SEQUOYAH NUCLEAR PLANT (SQN) - UNIT 1 CYCLE 15 CORE OPERATING
LIMITS REPORT (COLR) REVISION 1

SEQUOYAH UNIT 1 CYCLE 15
CORE OPERATING LIMITS REPORT

REVISION 1

Reason for Revision To incorporate changes in the FQ limit, K(Z) curve, and AFD limits due to a revised
Large Break LOCA analysis to improve operating margins

FIGURE 2B

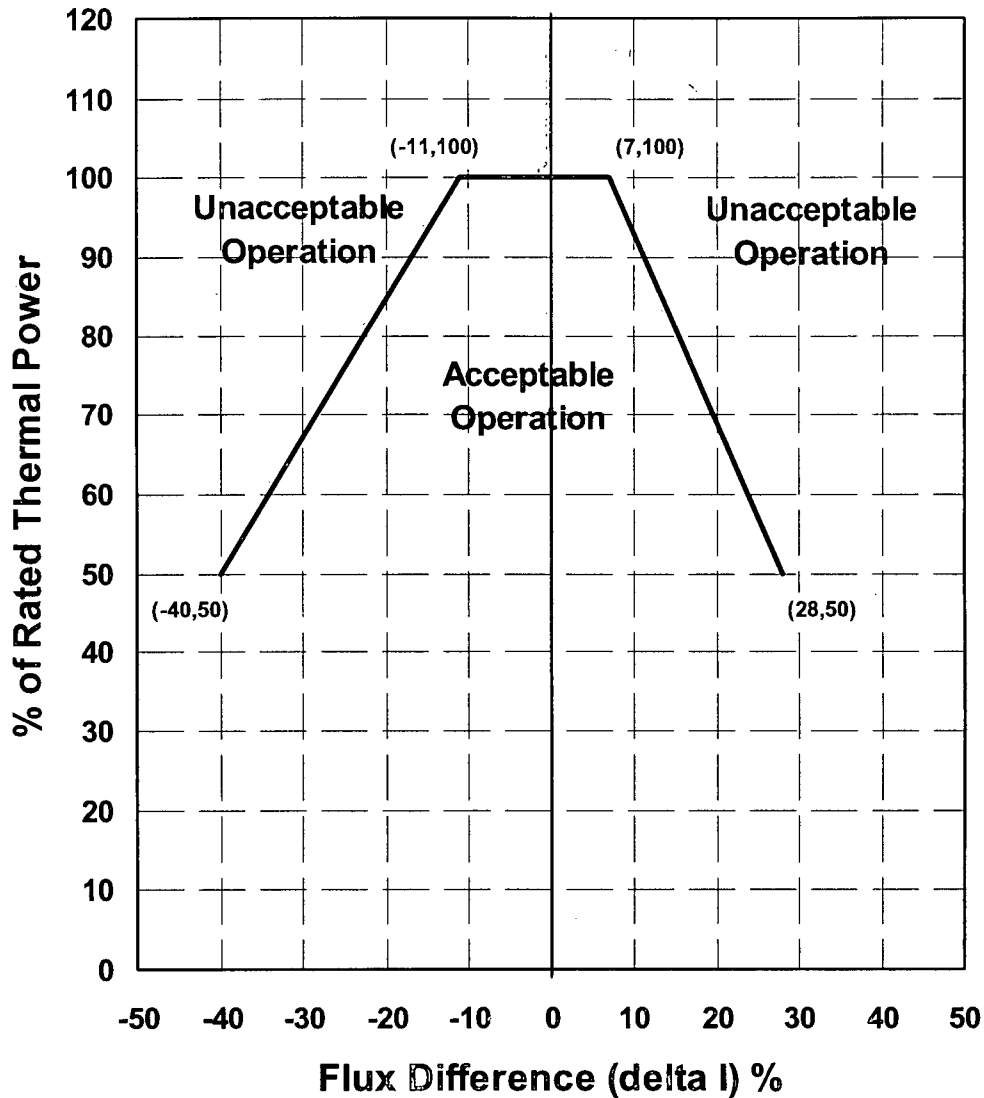
In accordance with the SQN Unit 1 Technical Specifications 6.9.1.14.c, enclosed is the revised Unit 1 Cycle 15 COLR. The COLR was revised to incorporate changes in the heat flux hot channel factor, elevation dependant adjustment factor, and the axial flux difference limits. These revised factors were necessary to improve operating margins for SQN Unit 1.

**Axial Flux Difference Limits
As A Function of Thermal Power
For Burnup Range of 254 ± 10 EFPD to 431 ± 10 EFPD**
